Access Compliance Report

Public Rights-of-Way

(Pedestrian Signals)

Intersection ID: N/A	Main Street:	Cross Street: N/A	Location: N/A
ADA ID: 00D43575FDC7	Signal Type: One Push Button-Non APS	Overall Compliance: No	Severity Score: BTN 1: N/A BTN 2: N/A No BTN: N/A
Codes/Mitigation Info/Possible Solution		Field Measurements/Component Compliance

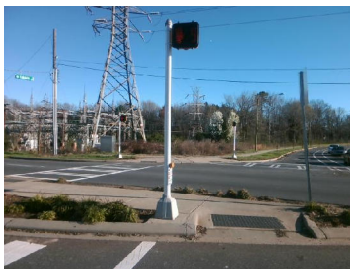
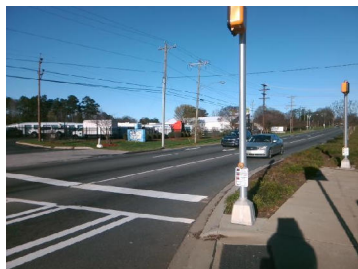
PROW/ADA: TMUTCD 4e.08, R404.3, R404.2, R404.7.3, R404.7.2

Possible Solutions: Replace Signal Push Button With APS Button on New Post. Remove & Relocate Sign.
